No. EC155-04A014

ALERT SERVICE BULLETIN

LIMITATIONS - Control rod double bearing Tail Gearbox (TGB)

Following additional tests and their analysis, the purpose of revision 6 of this ALERT SERVICE BULLETIN is to reinforce the monitoring criteria of the double bearing.

Flow chart for the bearing return process

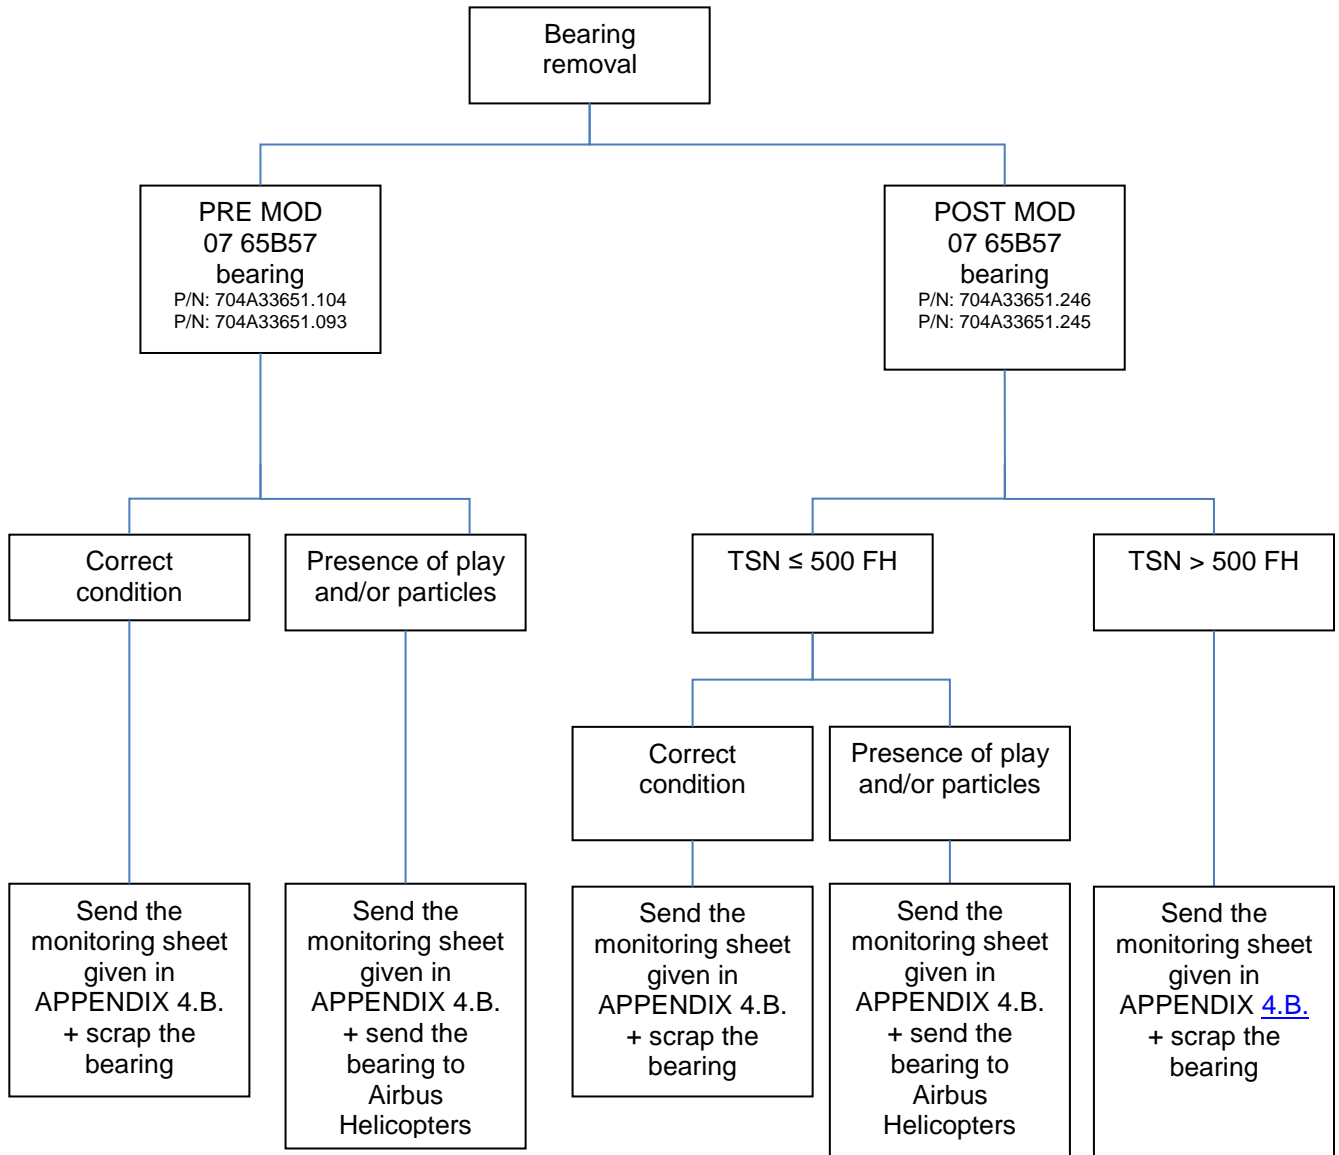
- Return the bearing monitoring sheet given in APPENDIX 4.B. to the Airbus Helicopters Technical Support:
Fax: +33 (0)4.42.85.99.66
E-mail: support.technical-dyncomp.ah@airbus.com or TechnicalSupport.Helicopters@airbus.com
- In accordance with the flow chart below, return the double bearing to the Airbus Helicopters Technical Support at the following address:

Figure 1: Example of abrasion on the magnetic plug

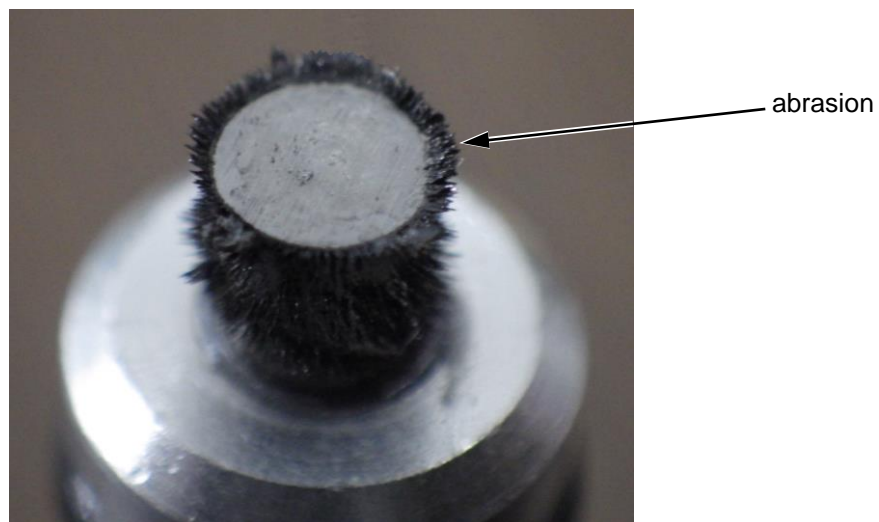
IN THE FLOW CHART, THE ABRASION PARTICLES (CLASS g AS PER MTC) MUST BE TAKEN INTO ACCOUNT IN ADDITION TO THE PARTICLE TYPES USUALLY TAKEN INTO ACCOUNT.

3.B.2. Checking the TGB manual magnetic plug or magnetic plug with electrical indicating

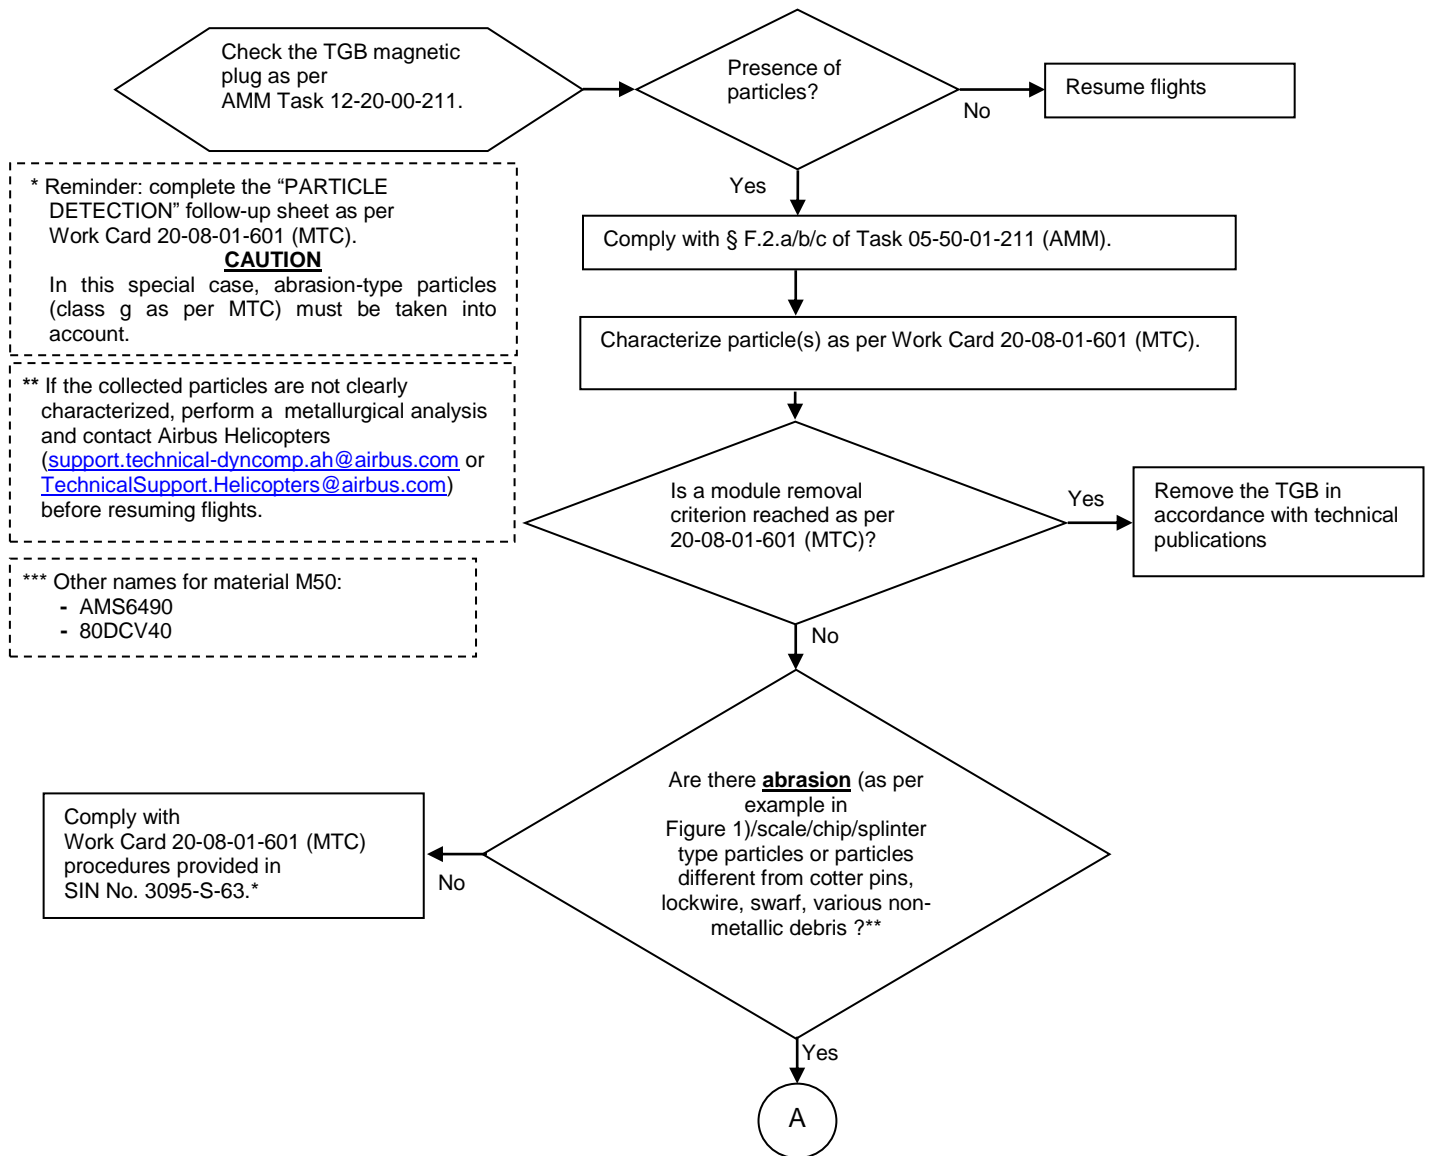
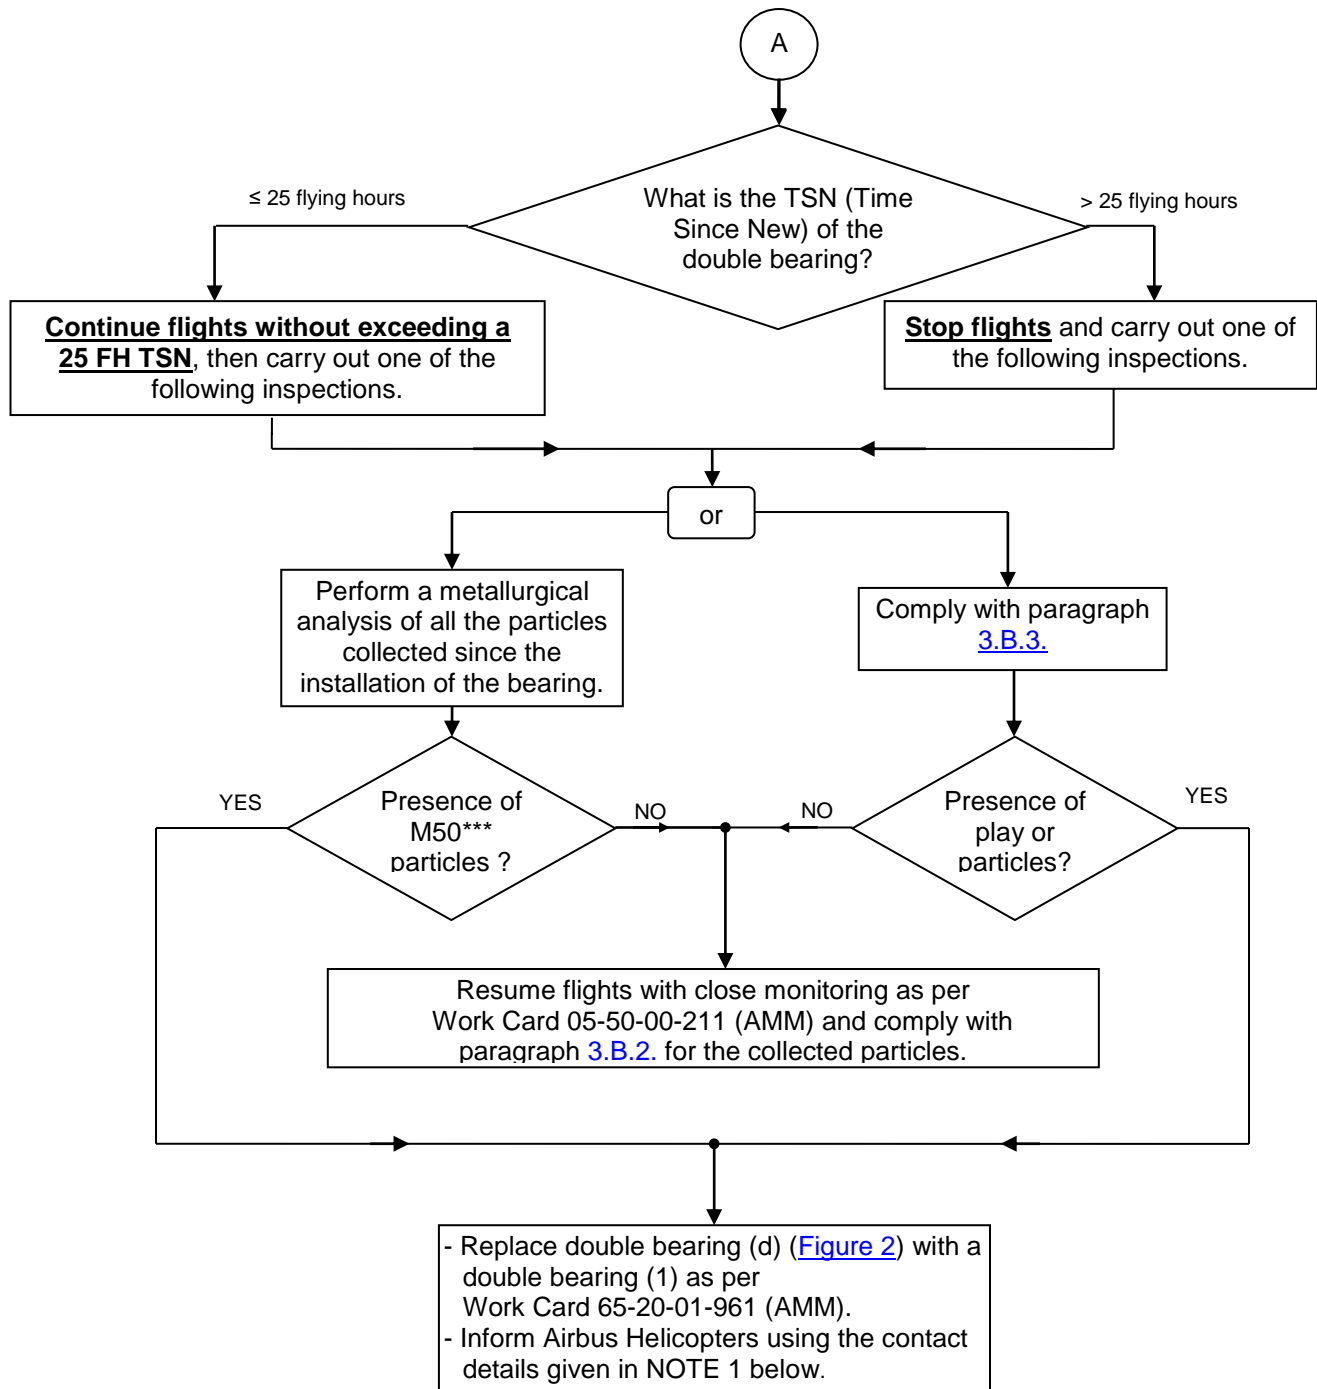
- Check if there are particles at the TGB magnetic plug as per AMM Task 12-20-00-211 and comply with [paragraph 3.B.2.](#) after each last flight of the day, **pending the next replacement of the double bearing** following the issue of Revision 0 of this ALERT SERVICE BULLETIN on May 4, 2016.
- Then, after replacement of the double bearing:
 - . For double bearings with less than 250 FH:
 - .. Comply with the flow chart as per paragraph [3.B.2.](#) within 10 FH from receipt of revision 6 of this ALERT SERVICE BULLETIN issued on the date indicated in the page footer without exceeding 20 FH since the last inspection of the TGB chip detector
 - . For double bearings with 250 FH or more:
 - .. Comply with the flow chart as per paragraph [3.B.2.](#) without exceeding 10 FH since the last inspection of the TGB chip detector

*** Other designations for material M50:
 - AMS6490
 - 80DCV40

Figure 2

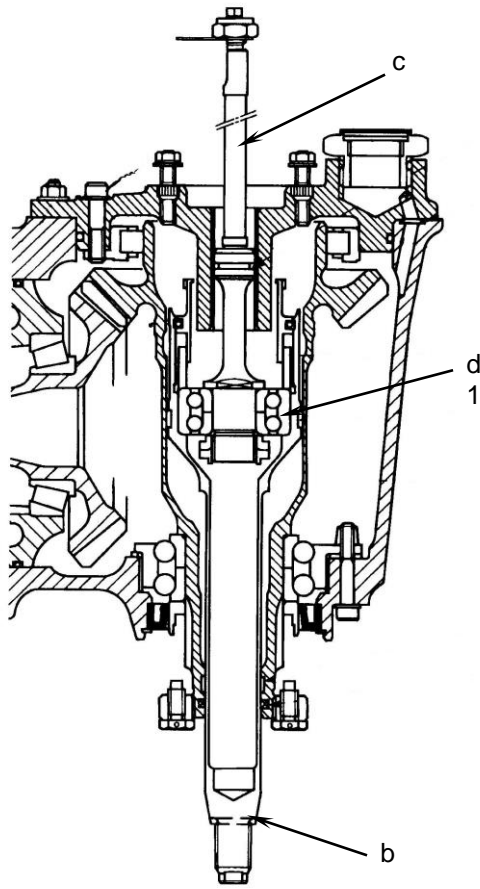
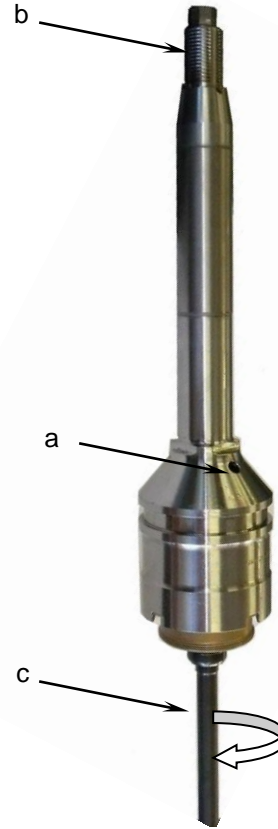
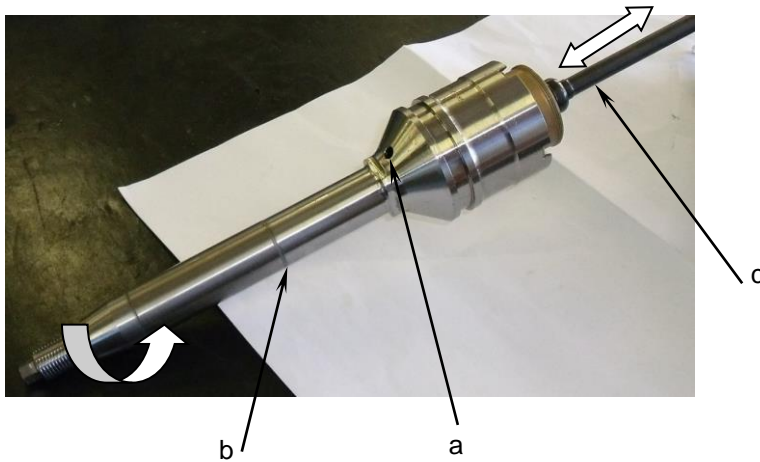
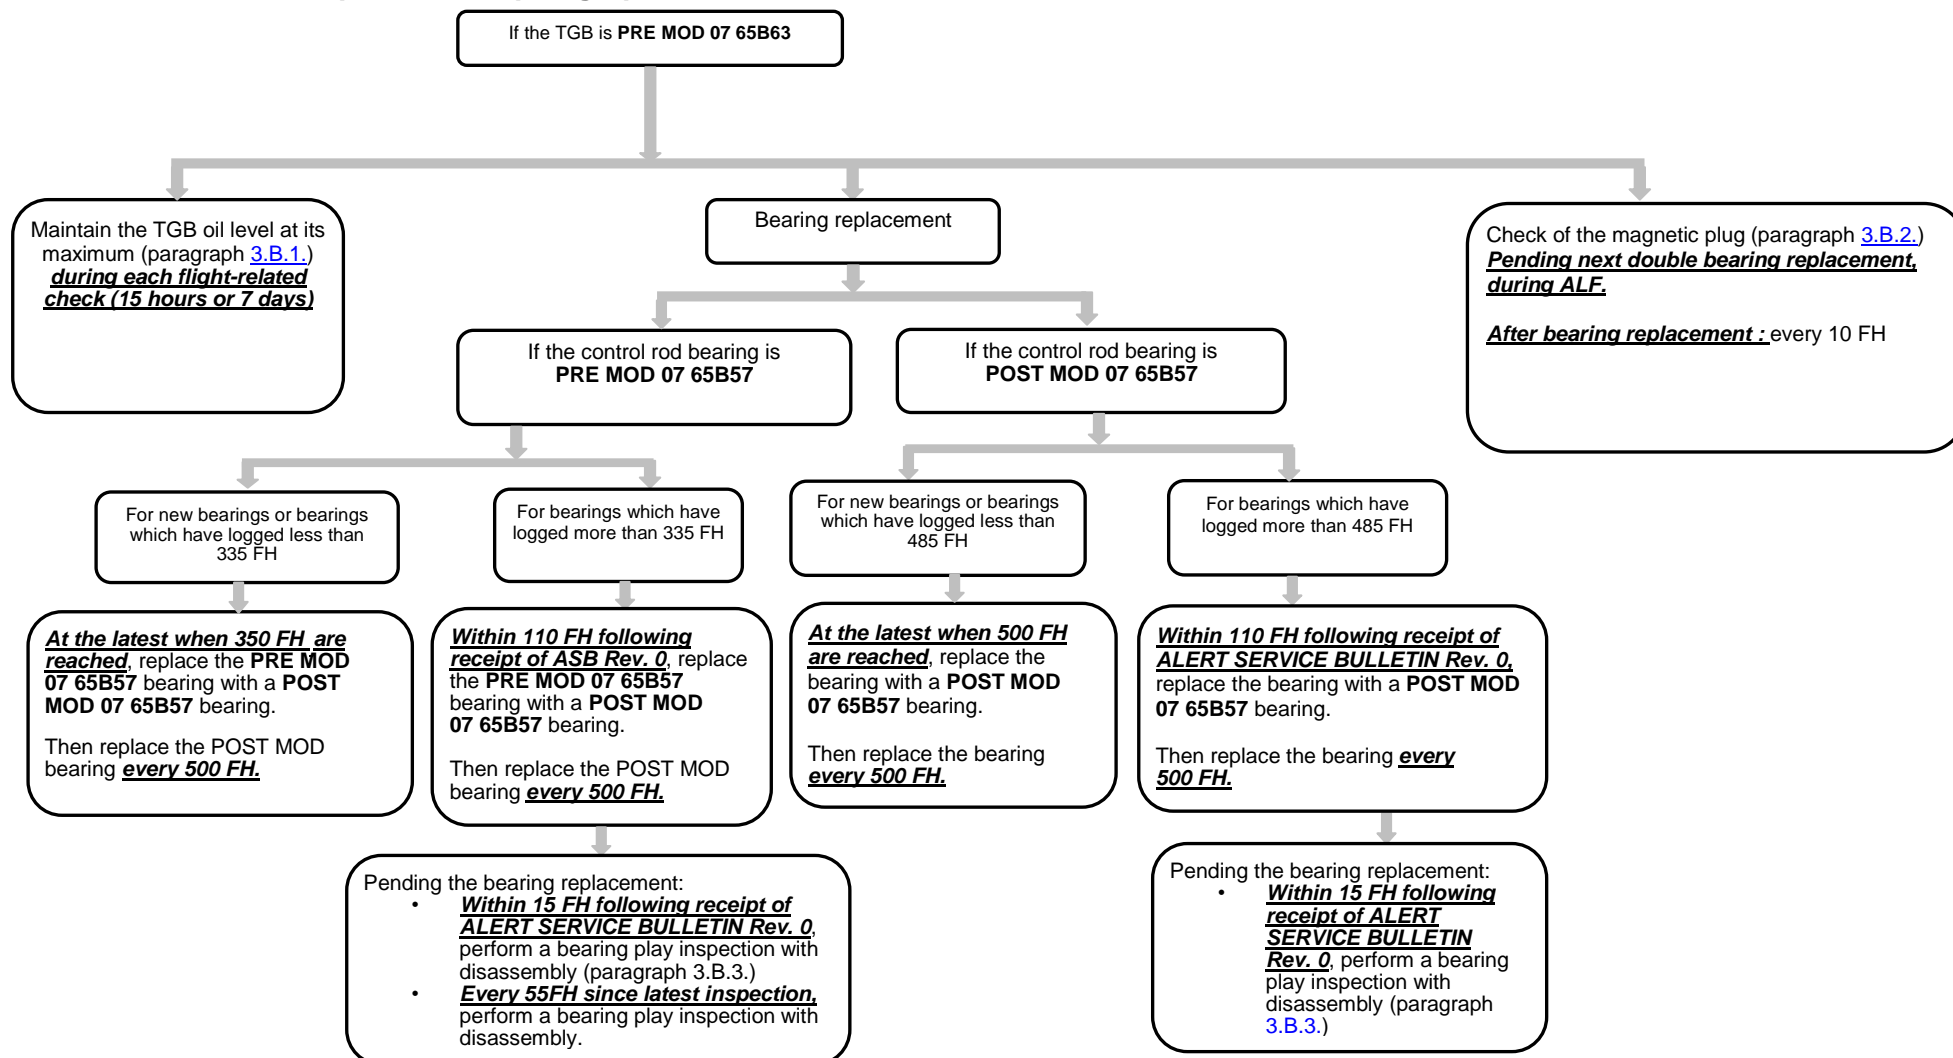
- Remove the control shaft/rod assembly as per paragraph 3.B.4.a.
- Carry out a tactile check to ensure that there is no axial play in double bearing (d) (Figure 1):
 - . Apply an alternating manual axial load to control rod (c) whilst turning control shaft (b) (**See [DETAIL A Figure 2](#)**).

- Clean the control shaft/rod assembly using WHITE SPIRIT (2) as per Work Card 20-04-01-102 (MTC):
 - 1) Inject WHITE SPIRIT (2) under pressure (for example using a can) into hole (a) of control shaft (b). (**See [DETAIL B Figure 2](#)**).

- . Hold shaft (b) in the vertical position pointing upwards.
 - . Manually turn control rod (c) several times to rinse double bearing (d) by draining the WHITE SPIRIT (2) through the bearing. (**See [Detail B Figure 2](#)**).

- 2) Insert WHITE SPIRIT (2) (for example using a can) in the area of the control shaft (b) that must be cleaned. (**See [DETAIL C Figure 2](#)**).
 - . Manually turn the control rod (c) several times to wash the double bearing (d) by draining the WHITE SPIRIT (2).

Make sure that the area pointed out in [DETAIL C Figure 2](#) is clean.
